Project/Property Address or Location: <b>975 North Hamilton Road</b>		Project Name/Business Name (if applicable): <b>The Shops at McKenna Creek</b>	
Parcel ID No.(s): <b>025-009953</b>	Current Zoning: <b>PCC</b>	Total Acreage: <b>5.19</b>	
Please check all that apply:			
SITE PLAN <input checked="" type="checkbox"/>	LANDSCAPING <input checked="" type="checkbox"/>	BUILDING DESIGN <input checked="" type="checkbox"/>	DEMOLITION <input type="checkbox"/> <small>only applicable to Code Chapter 1150, Ohio, Gahanna</small>
SIGNAGE <small>- please use the Permanent Sign Permit Application</small>			
Additional Information (if applicable): <b>Landscaping plan and lighting plan for the subject site were submitted as part of Mount Carmel's pending Design Review application.</b>			
APPLICANT Name (primary contact) -do <u>not</u> use a business name: <b>William J. Schottenstein</b>		Applicant Address: <b>107 S. High Street, Suite 300, Columbus, OH 43215</b>

### 975 N. Hamilton Road, Shops at McKenna Creek – Design Review Responses to comments dated November 27, 2019

RE: Project 975 N Hamilton Shops at McKenna Creek Design Review

## PLANNING AND DEVELOPMENT STAFF REPORT

**A-4**

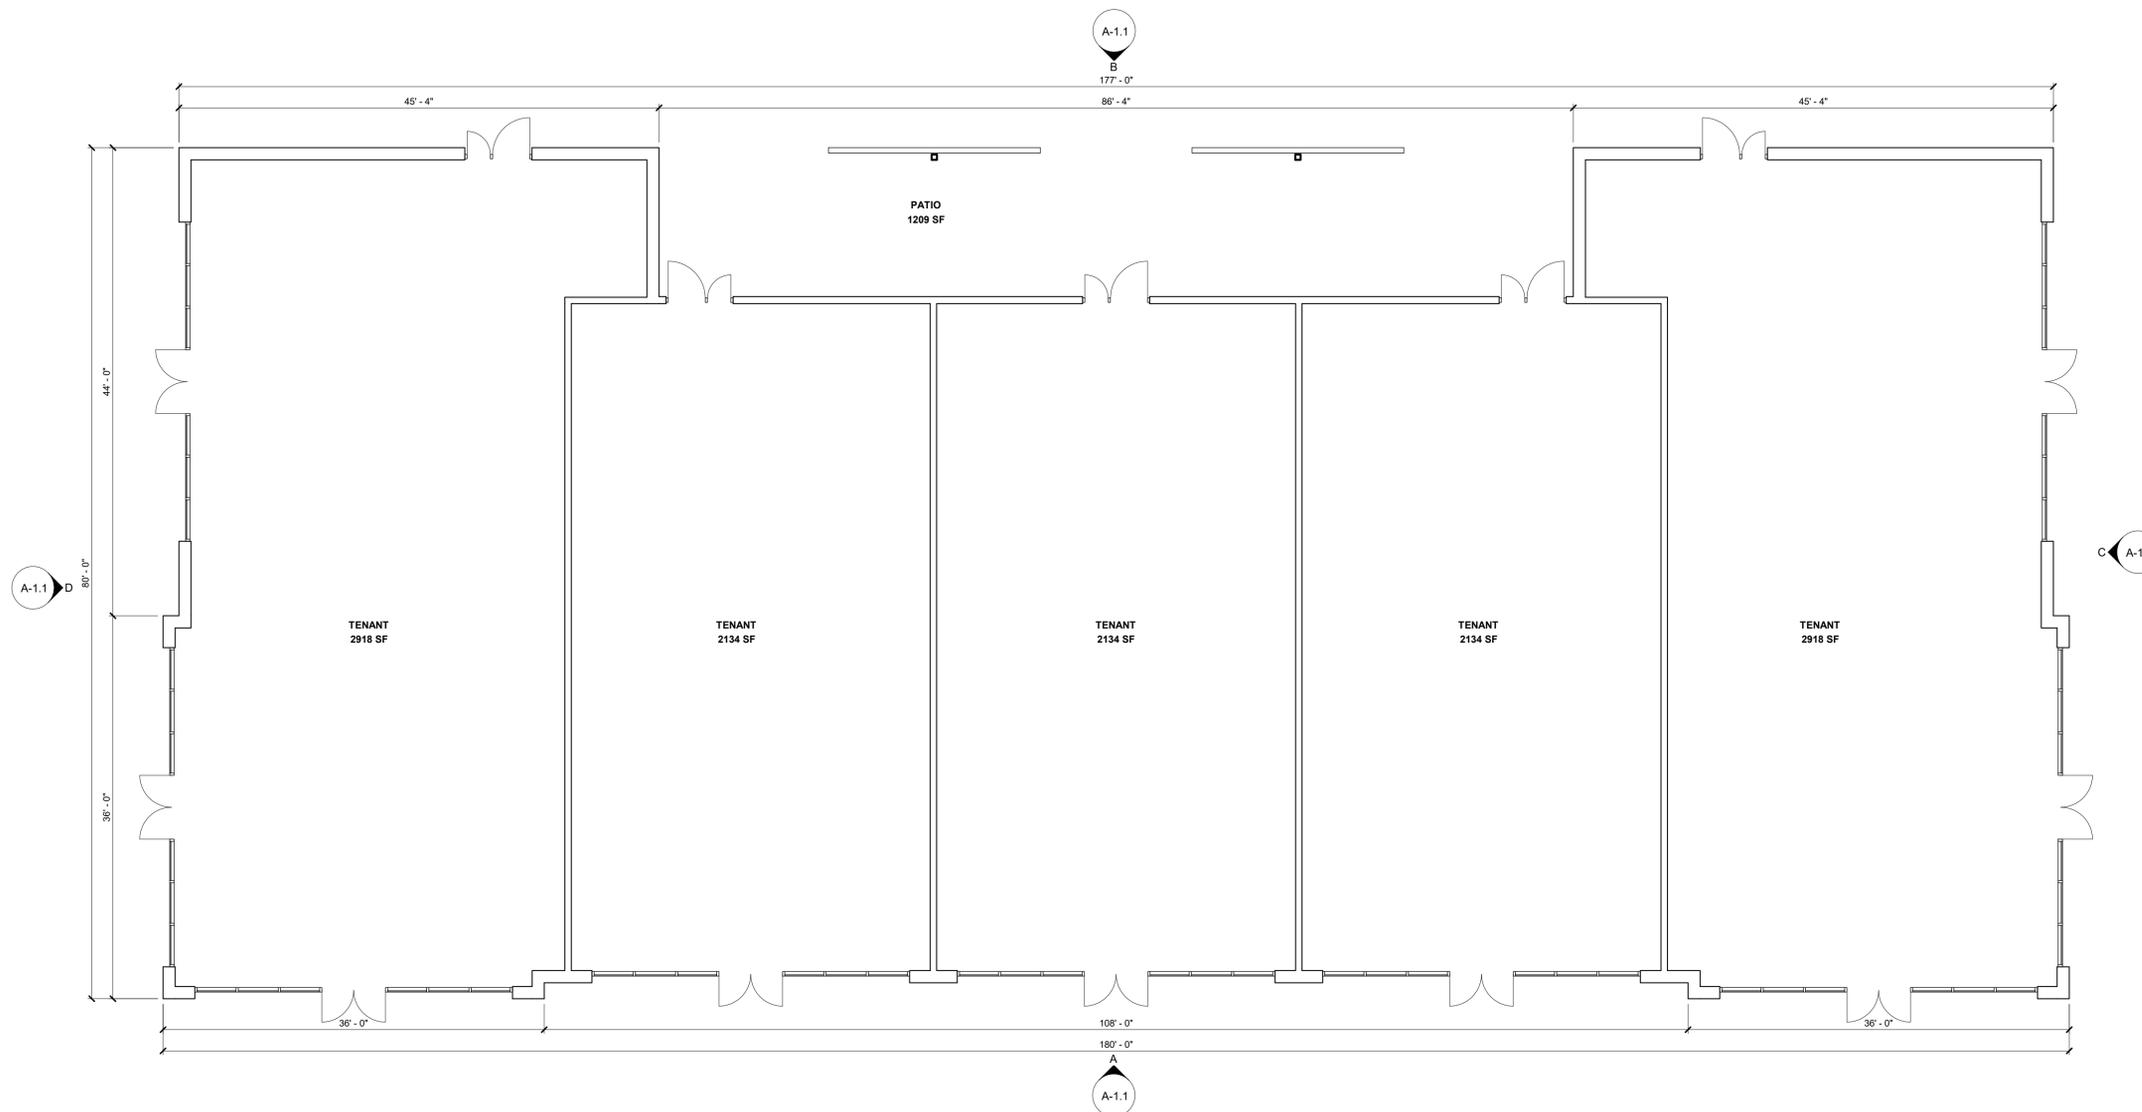
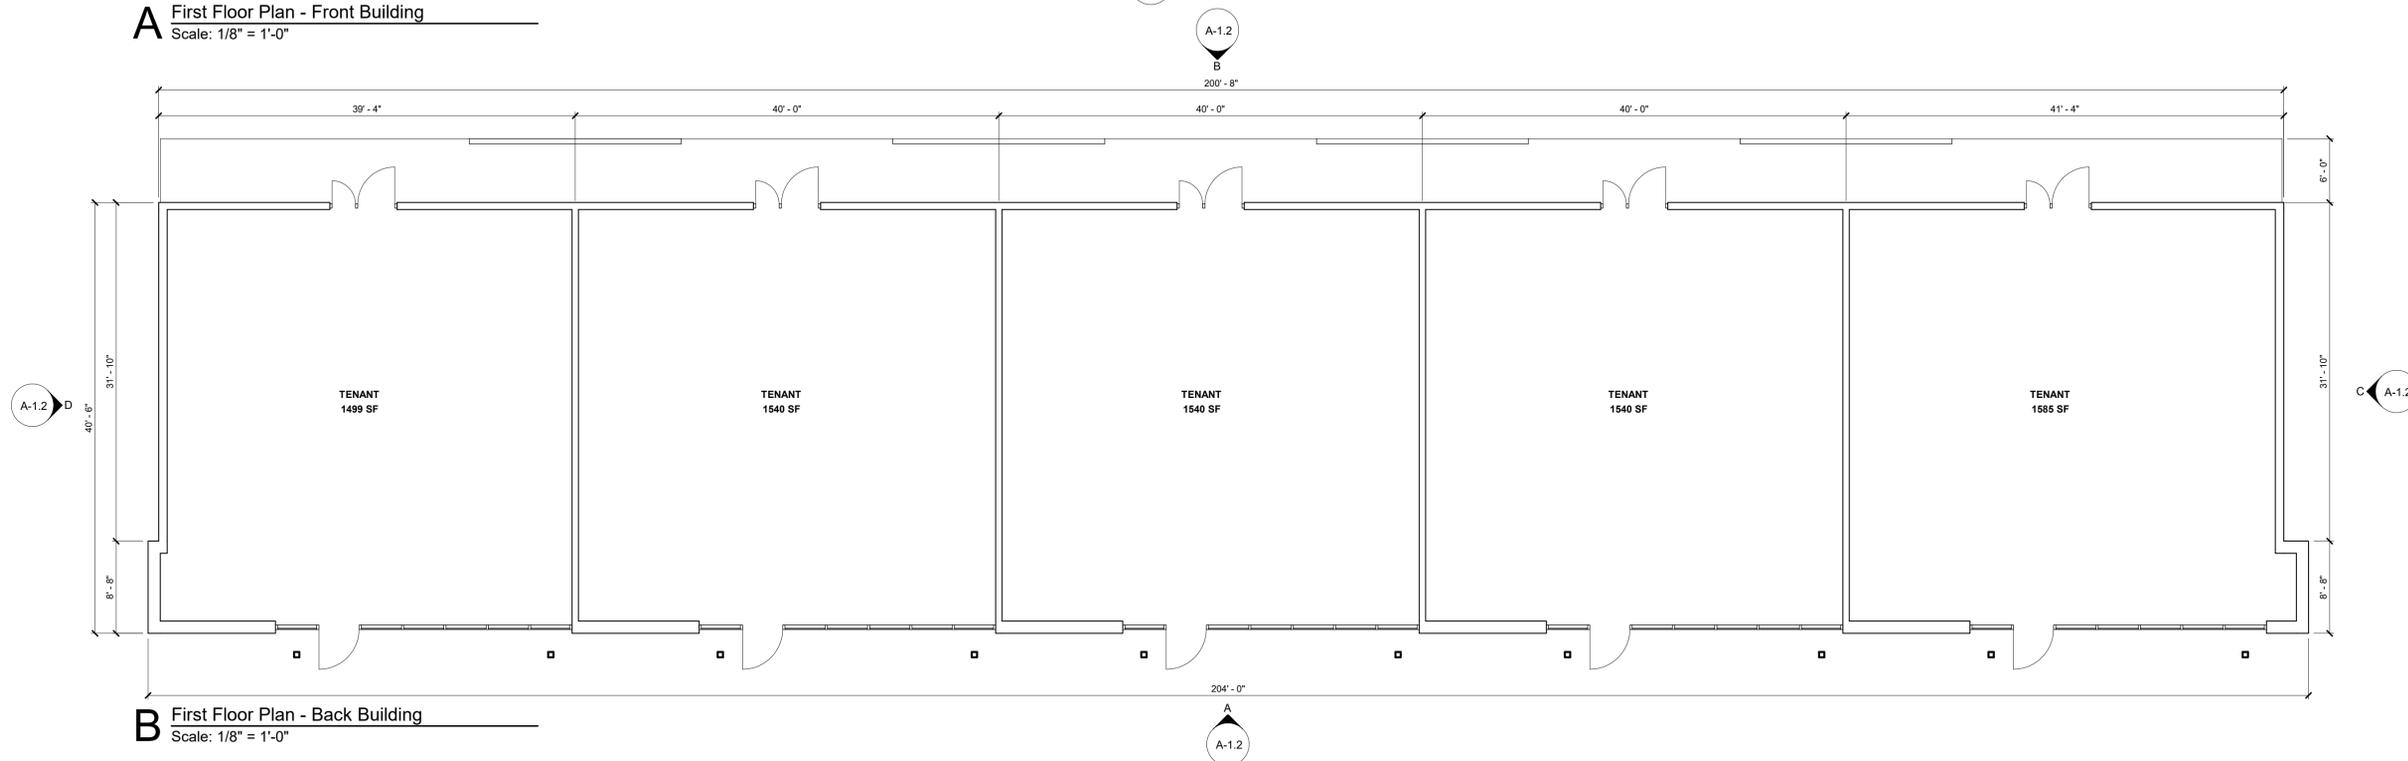
4. **Comment** – The approved applications had three buildings on the site. The request is for two of those buildings. It would be helpful to have a site plan that clearly indicated which elevation is for which building on the site plan. For example, it appears that the building depicted on sheet A-1.1 is for the western most part of the building but that is unclear. Please submit a site plan that identifies which elevations/renderings are for which building. This information will help Planning Commission better understand the request.

**Response** – Elevation markers have been added to Sheet A-4 for clarification. The building shown in View A is the larger building located closest to Hamilton Road. The building shown in View B is the smaller building located toward the rear of the site, closest to access from Beecher Road. These notations have also been added to the landscape plan for reference only.
